**PLANNING APPROVAL &
SUBDIVISION STAFF REPORT****Date: March 6, 2014****NAME**

Sweet Pilgrim Baptist Church Subdivision

LOCATION359 St. Charles Avenue
(North side of St. Charles Avenue, 435'± West of Dr.
Martin Luther King Drive).**CITY COUNCIL
DISTRICT**

Planning Approval to allow a church in an R-1, Single-Family Residential District, and Subdivision approval to create one legal lot.

SITE PLAN

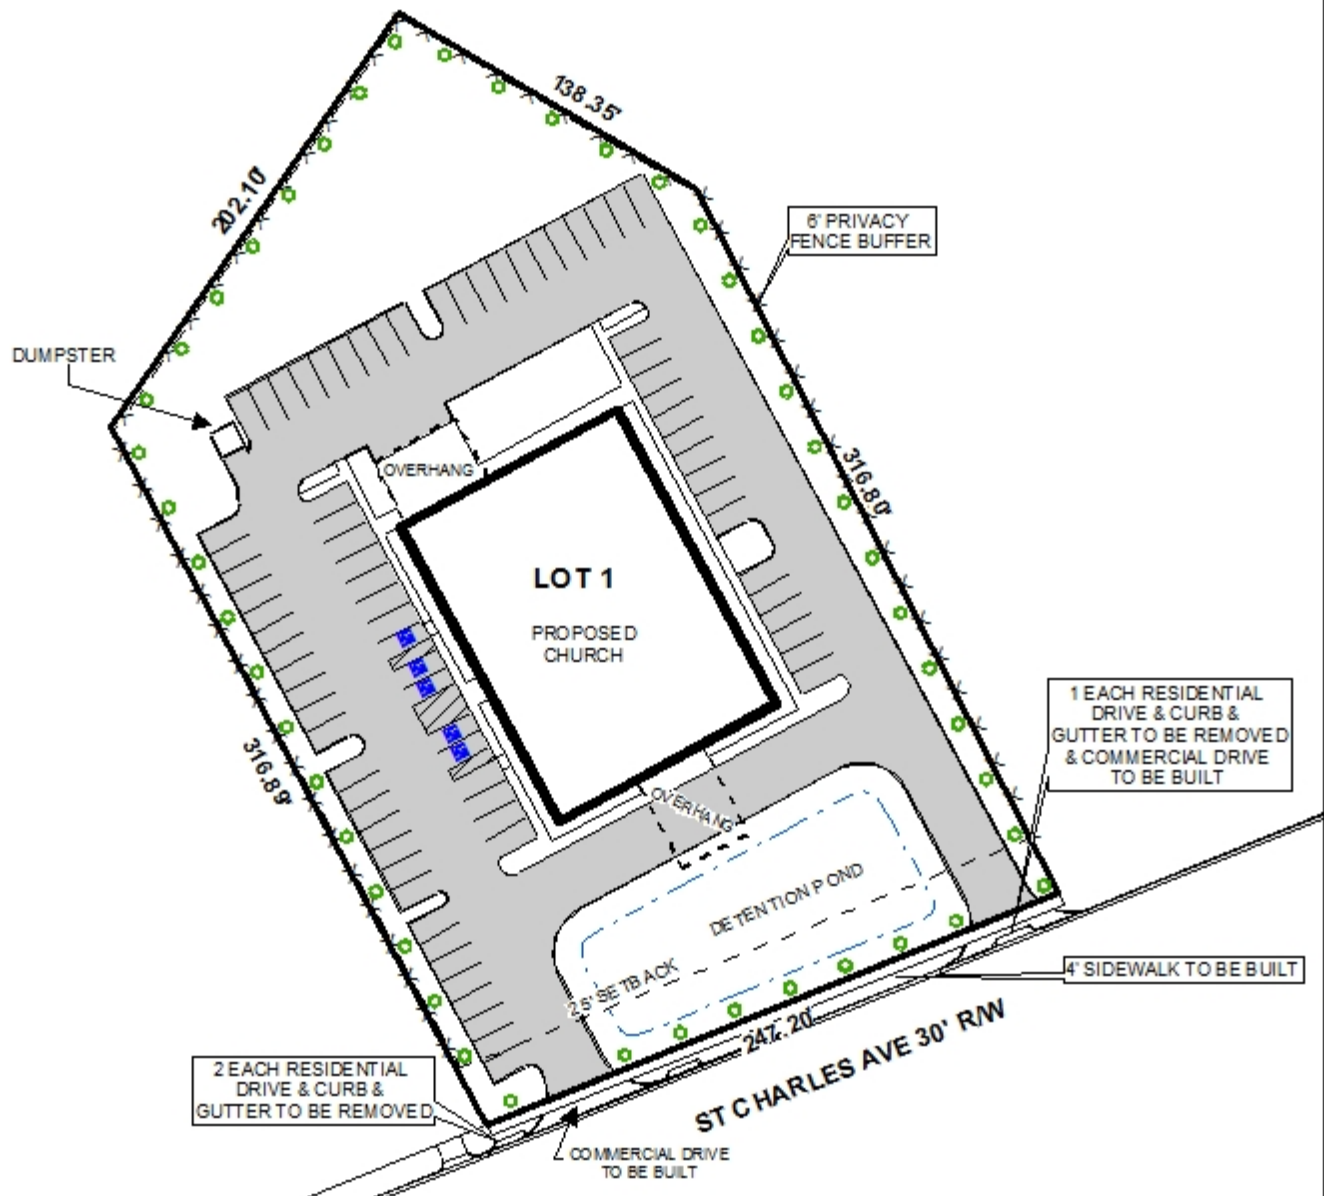
The application does not show the existing Live Oak trees on the site. Urban Forestry is recommending holding the application over and having a revised site plan showing how the proposed development will impact the existing Live Oak trees.

The site fronts onto St. Charles Street, a minor street with curb and gutter. As a minor street with curb and gutter, the right-of-way should be 50'. The preliminary plat submitted illustrates the current right-of-way as being 40'. Therefore, dedication should be made to provide 25' from the centerline.

The submitted site plan illustrates three existing residential curb cuts, which are labeled as, "to be removed". As a means of access management, the site should be limited to two curb cuts to St. Charles Avenue. A note stating this should be placed on the site plan, if approved.

Section 64-6.A.6. of the Zoning Ordinance requires 73 parking spaces; the site plan illustrates 79 parking spaces on the site. It should be noted that after required dedication, one or two parking spaces may have to be removed to allow for the curb cut, however the site will still exceed the minimum number of required parking spaces. It should also be noted that parking spaces that do

not have curbing present should have bumper stops provided. Because there are more than 25 parking spaces on the site, a note should be placed on the site plan stating that parking lot lighting will be provided in compliance with Section 64-6.A.3.C. of the Zoning Ordinance. Section 64-6.A.3.C. of the Zoning Ordinance also requires the submittal of a photometric site plan of the parking areas when applying for building permits.

The site plan illustrates a dumpster which meets setback, and is noted as being screened on three sides as required; however, the note should be revised to state that the screen will be a privacy fence or wall at least as high as the dumpster per Section 64-4.D.9. of the Zoning Ordinance.

A 6' high privacy fence is illustrated along the side and rear property line to serve as a residential buffer; however, the site plan should be revised to indicate that the fence will come down to 3' high within the 25' front setback.

The proposed site plan illustrates full compliance with landscaping and tree planting requirements; however, as Urban Forestry has noted, there is no notation showing the size and location of existing Live Oak trees.

- 1) dedication to provide 25' from the centerline of St. Charles Avenue;
- 2) revision of the 25-foot minimum building setback line to reflect dedication;
- 3) revision of the site plan to illustrate the location and size of existing live oak trees on the site, per Urban Forestry comments;
- 4) revision of the site plan to note the height and material of the dumpster screening;

- 6) placement of a note limiting the site to two curb cuts to St. Charles Avenue;
- 7) placement of a note on the site plan state that parking lot lighting will be provided in compliance with Section 64-6.A.3.C. of the Zoning Ordinance;

- 8) depiction and provision of a 6-foot high wooden privacy fence around the perimeter of the site where it abuts existing residential development, with the exception of within 25-feet of a street right-of-way, where the fence shall not exceed 3-feet in height;

- 9) illustration of bumper stops where curbing is not provided; and
- 10) full compliance with all other municipal codes and ordinances.
